# Work Order ID 84537

Item Name: Crosstube Aft

# **ENGINEERING CHANGE NOTICE** **DART AEROSPACE LTD**

DRAWING NO. D206-667-243	TITLE CROSSTUBE ASS'Y (206L HIGH AFT)	REV. C	<b>DART AEROSPACE LTD ENGINEERING ORDER</b>		D.E.O. NO. D206-667-243-C-1	SHEET NO. SHEET 1 OF 1	SCALE NTS
DRAWN <i>q</i>	CHECKED <i>ADS</i>	MFG. APPR. <i>RB</i>	APPROVED <i>MP</i>	DE APPR. <i>#</i>			
DATE 11.07.15	DATE 11.07.20	DATE 11.07.21	DATE 11/07/21	DATE 11.07.21

**FIGURE 1 - CROSSTUBE SUPPORT**

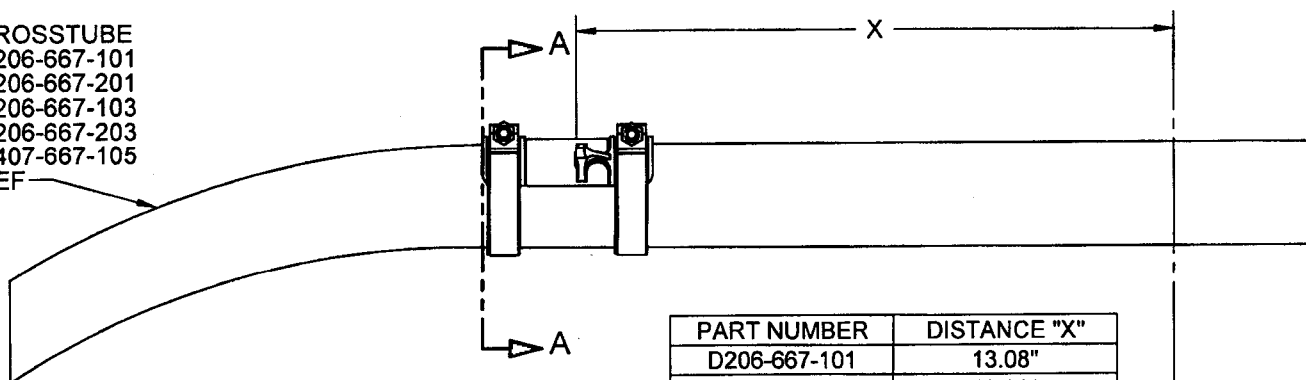
For D206-667-101/-201/-103/-203 or D407-667-105 crosstubes at CHG 003 or later, the D2856-400-694/-773 abrasion strip has been removed, the center D2891-1 or D2892-1 support has been bonded onto the crosstube using Magnabond 6398 and D3595-063-395/-450 Rubber Cushions have been installed underneath the MS21920-20/-22 Clamps. Amend parts list of the IIN-D206-667 Section 5 and ICA-D206-667 Section 32.8 as follows:

To prevent the supports from shifting on the D206-667-101/-201/-103/-203 or D407-667-105 crosstubes at CHG 002 or earlier, the D2891-1/D2892-1 supports should be removed and re-installed as follows:

- Apply a 0.03" to 0.06" thick layer of Magnabond 6398 underneath the D2891-1/D2892-1 support and re-install the support on the crosstube as shown in Figure 1. Position and secure the D2891-1/D2892-1 support on the crosstube using MS21920-20/-22 Clamps. Install a D3595-063-395/-450 Rubber cushion underneath each MS21920-20/-22 Clamp. Torque clamps 80-100 in-lb. Let the D206-667-101/-201/-103/-203 or D412-667-105 crosstube assembly cure as per the Magnabond 6398 instructions before re-installing the crosstube on the aircraft.

MAGNABOND 6398 BETWEEN D2891-1/D2892-1  
SUPPORT AND CROSSTUBE

D3595-063-395/-450 RUBBER CUSHION  
(REF) (2 PLACES)

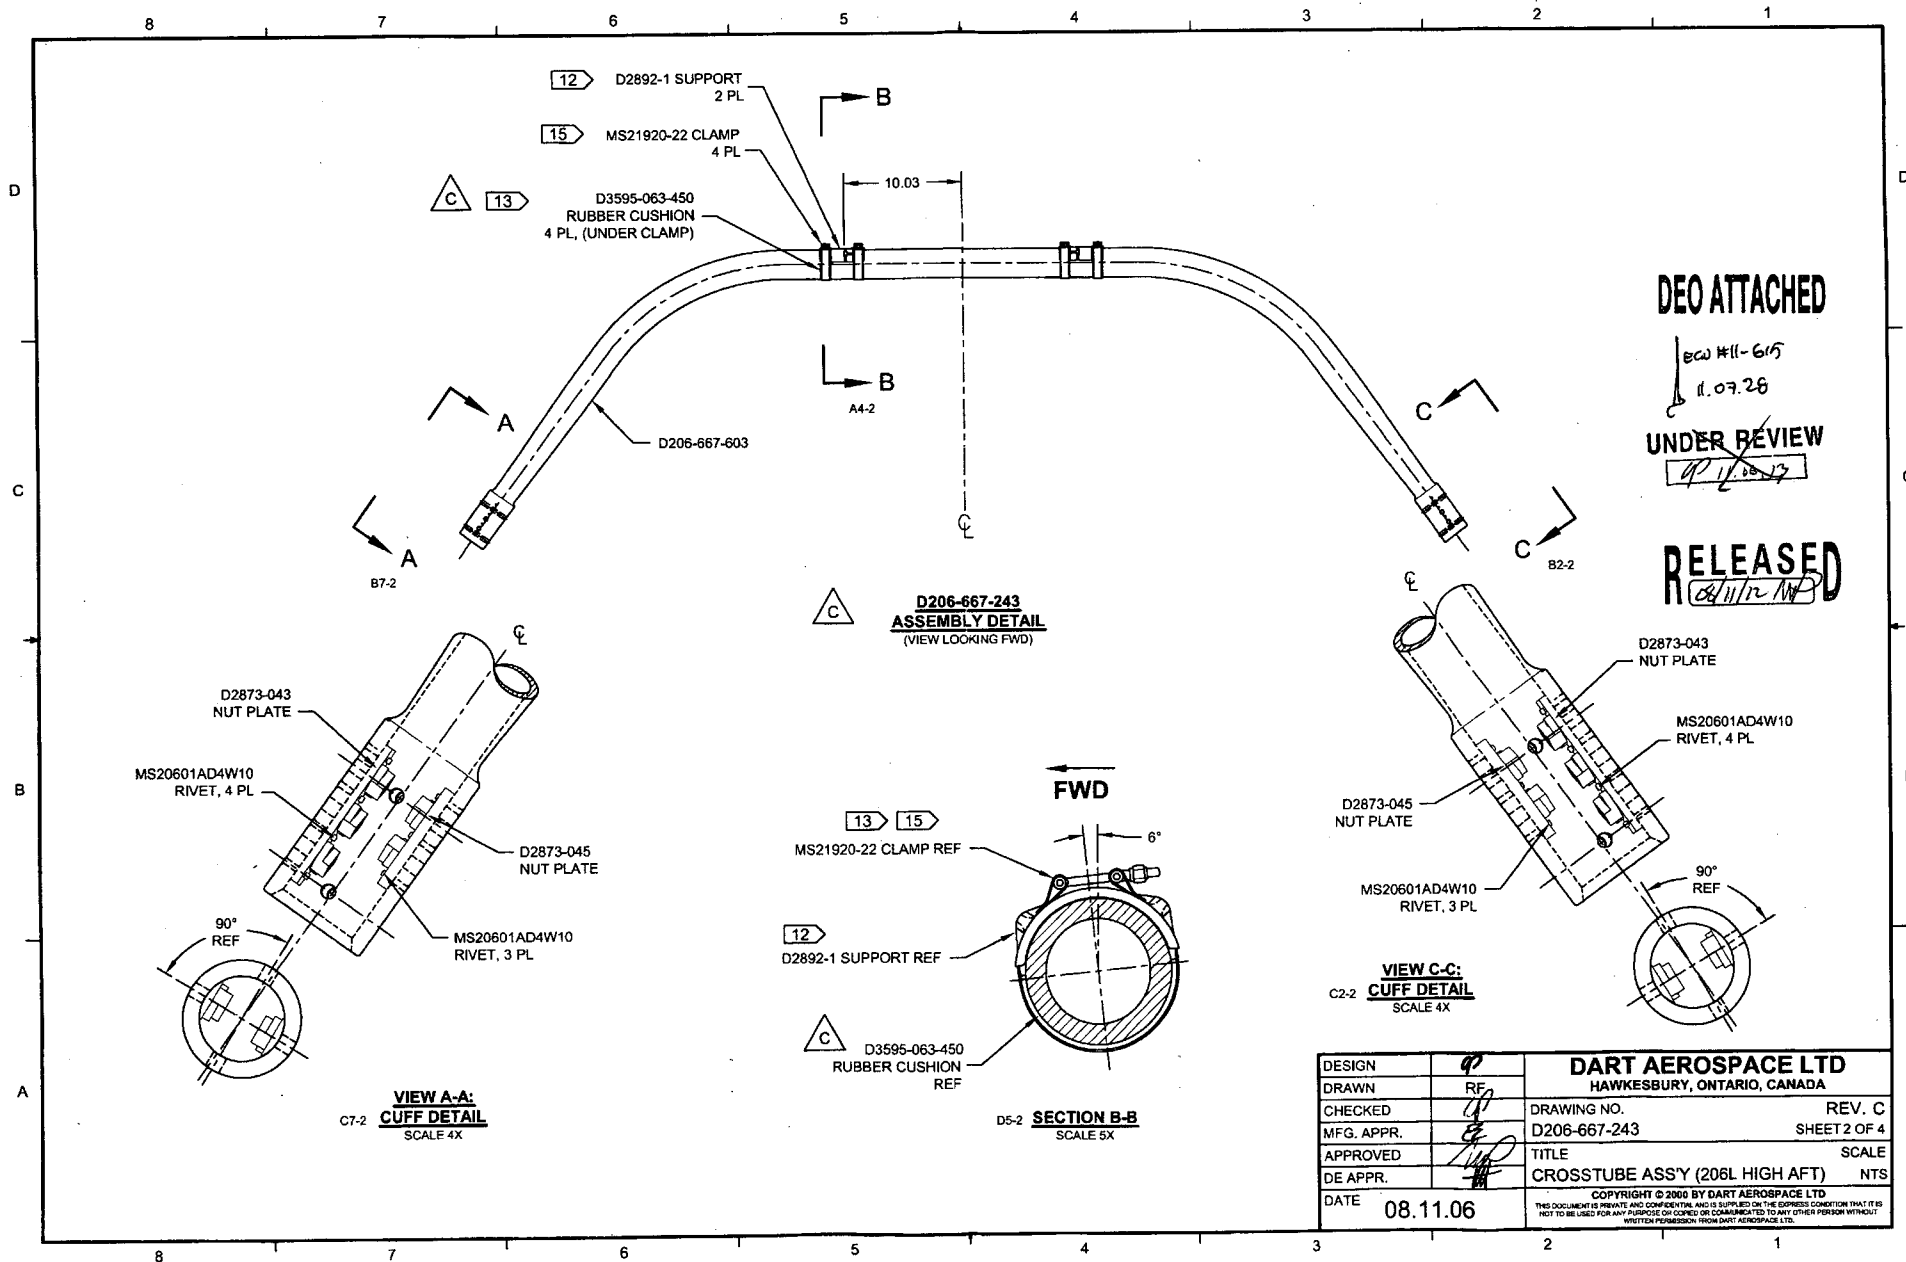
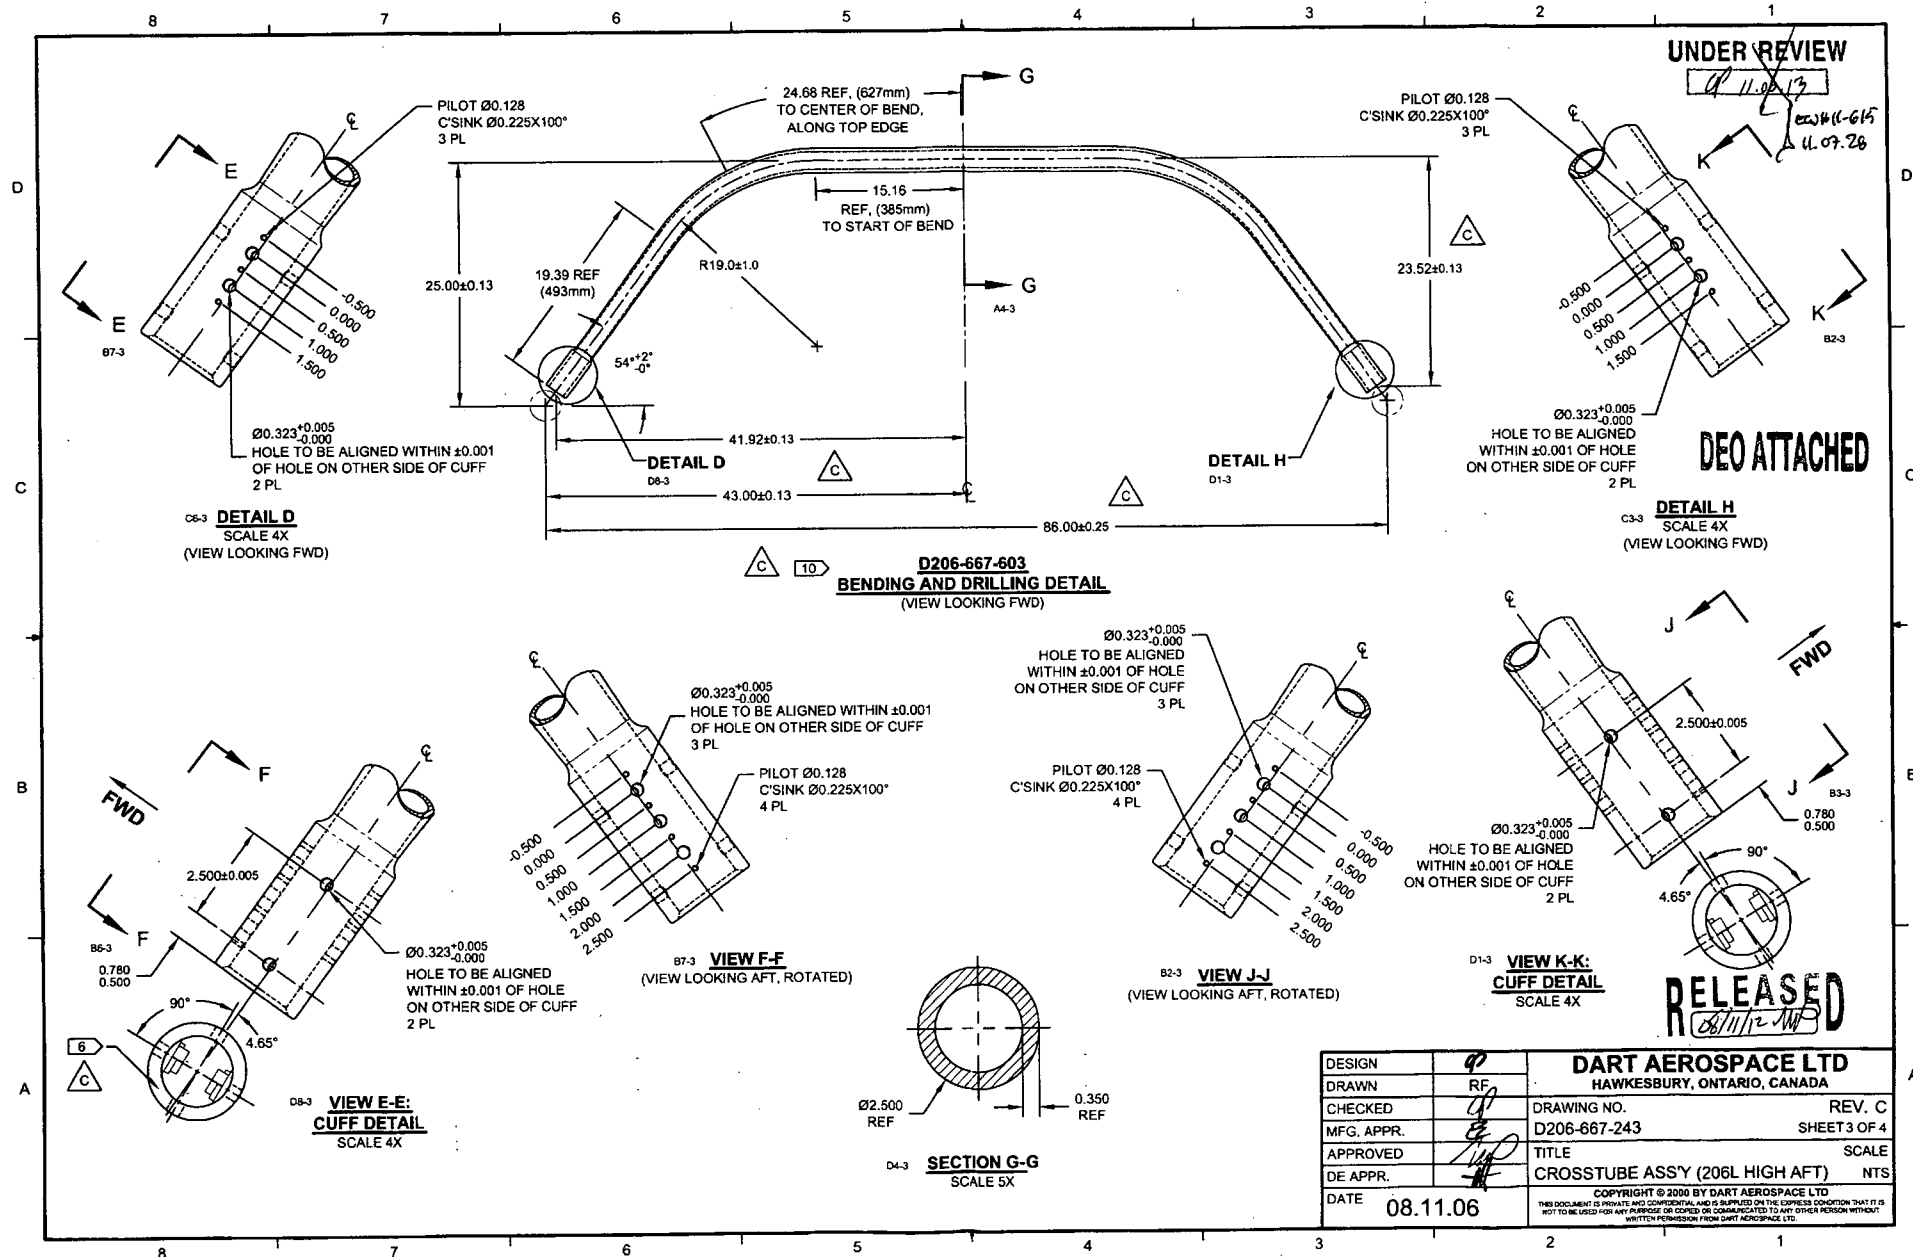
ECO #11-615  
11.07.26

**PURPOSE:**

REPLACE MAGNOBOND WITH PROSEAL.

NOTE 12 & 15, SHEET 1 IS AMENDED AS FOLLOWS:

Item	Qty -243	Part Number	Description
9	A/R	PROSEAL 890 B-2	SEALANT, AMS-S-8802 CLASS B-2

12) TO INSTALL D2892-1 SUPPORT: ABRASE MATING SURFACE OF SUPPORT AND CROSSTUBE WITH 180-GRIT SANDPAPER AND REMOVE RESIDUE WITH MEK (OR EQUIVALENT). APPLY A 0.04" TO 0.07" THICK LAYER OF PROSEAL 890 CLASS B-2 (OR AMS-S-8802 CLASS B-2) SEALANT TO MATING SURFACE OF SUPPORT.

15) TORQUE CLAMPS 80 TO 100 IN-LB. ENSURE AT LEAST 1.5 THREADS SHOWING IN SAFETY AND THAT NUT HAS NOT BOTTOMED-OUT AFTER TORQUING. **PRIOR TO PACKAGING, RE-CHECK TORQUE ON CLAMPS AFTER PROSEAL 890 SEALANT HAS CURED FOR 72 HOURS.**
